#### 181st session

## **Proposal for Supplement 7 to the 01 series of amendments to UN Regulation No. 129 (Enhanced Child Restraint Systems)**

### **Submitted by the Working Party on Passive Safety \***

Figure 2  
**ECRS Measurement Device - Side and Front View of the measuring device**

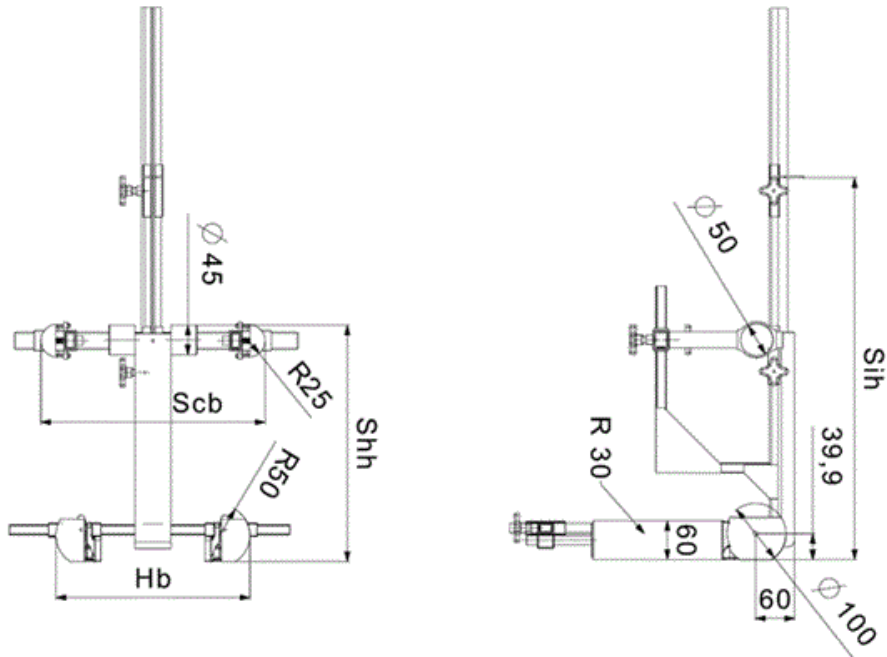
Annex 18., amend to read:

For integral or non-integral ECRS the device shown in Annex 18, Figure 2 shall be used.

The mass of the devices described in Figure 2 and Figure 3 shall be 10 kg +/- 1 kg.

All measurements shall be taken with the device base in contact with the seat pan of the ECRS and the device backrest in contact with the backrest of the ECRS. All lateral dimensions shall be measured under a contact force of 50 N with the devices described in Figure 2 and Figure 3 of this annex.

Figure 3  
**Side and Front View of the measuring device for measurements applicable to Enhanced Child Restraint Systems that feature an impact shield**

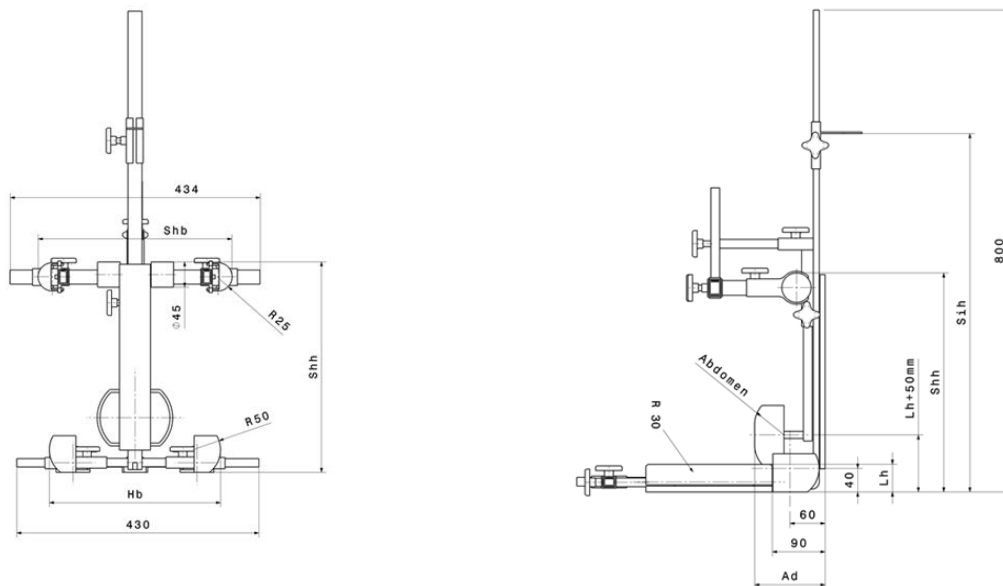
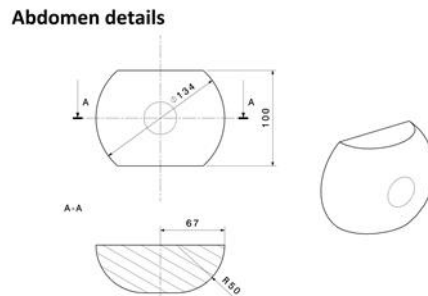
For ECRS with an impact shield the device shown in Annex 18, Figure 3 shall be used.
